## Request for Information ("RFI")

TO: Brian T. Dunn, AIA KG+D Architects, PC 285 Main Street Mount Kisco, NY 10549 <b>PROJECT:</b> Harrison, Town-Village Recreation Center Phase 2 270 Harrison Avenue Harrison, NY 10528 <b>PROJECT NUMBERS:</b> 2020-1005 /		FROM: Piazza Inc. 3 W. Stevens Ave HAwthorne, NY 10532			
		ISSUE [	ATE: 03/25/2025	<b>RFI No.</b> RFI 053 - 2nd Floor Ceiling Changes	
		REQUESTED REPLY DATE: ASAP COPIES TO:			
RFI DESCRIPTION:	Per discussion during the 3/19/25 co ductwork will not fit in certain areas, Please see the attached 2nd floor duc for engineer and architect review.	, and that t	ne ceilings will need to	o be lower	ed appropriately.

Project: <u>HARRISON REC CENTER PHASE 2</u>		<b>Date</b> : <u>3/25/25</u> Log No.: <u>LJC# -06</u>	
<b>Drwg</b> .: <u>N/A</u>	<b>Spec</b> .: <u>N/A</u>		Area: 2 <sup>ND</sup> FLOOR
Directed To: <u>PIAZZA BROT</u>	HERS		Date Required:
Impact: <u>N/A</u>			
<b>Regarding</b> : <u>CEILING HEIGH</u>	HTS FOR DUCTWO	RK	
<b>REQUESTED BY:</b> <u>LJC/TAC</u>	CONIC	_ cc:

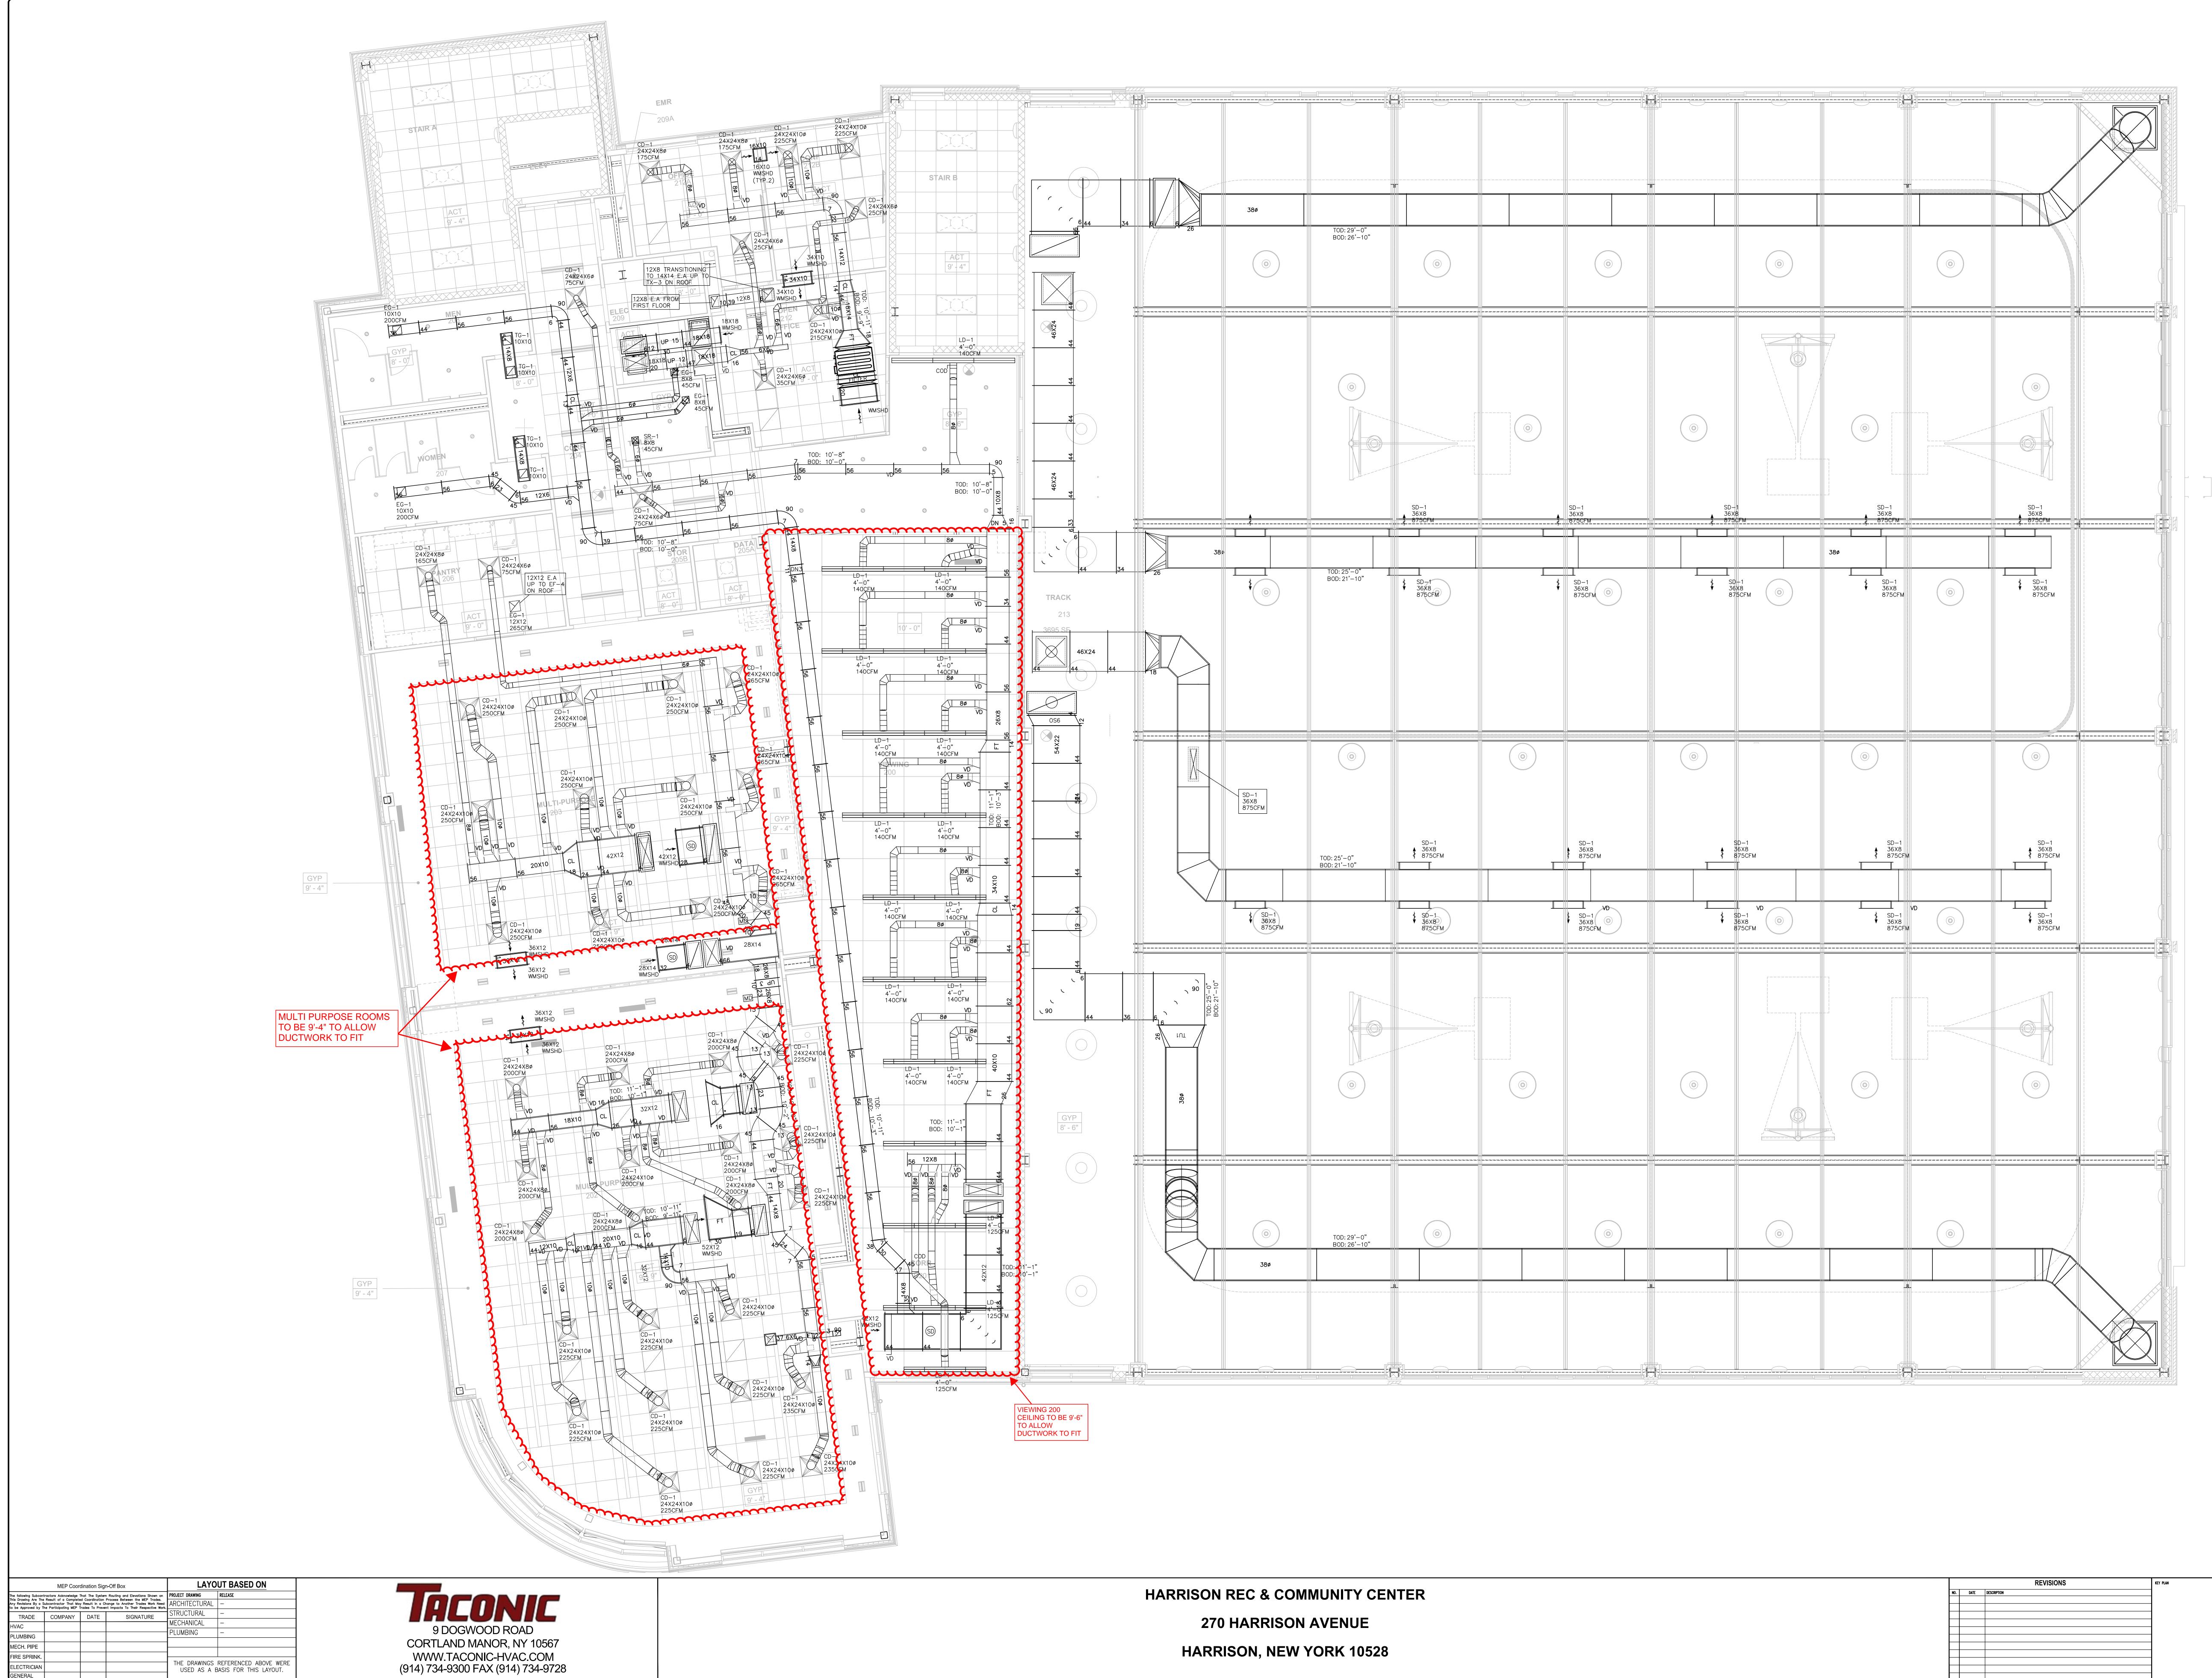
Per discussion during the 3/19/25 coordination meeting, it was noted that the 2<sup>nd</sup> floor ductwork will not fit in certain areas, and that the ceilings will need to be lowered appropriately. Please see the attached 2<sup>nd</sup> floor duct shop drawing with comments indicating the required changes for engineer and architect review.

Based on the coordination meetings held with the design team and the contractors it is acceptable to lower the 2nd floor ceilings to 9'-4" AFF to align with the perimeter soffit.
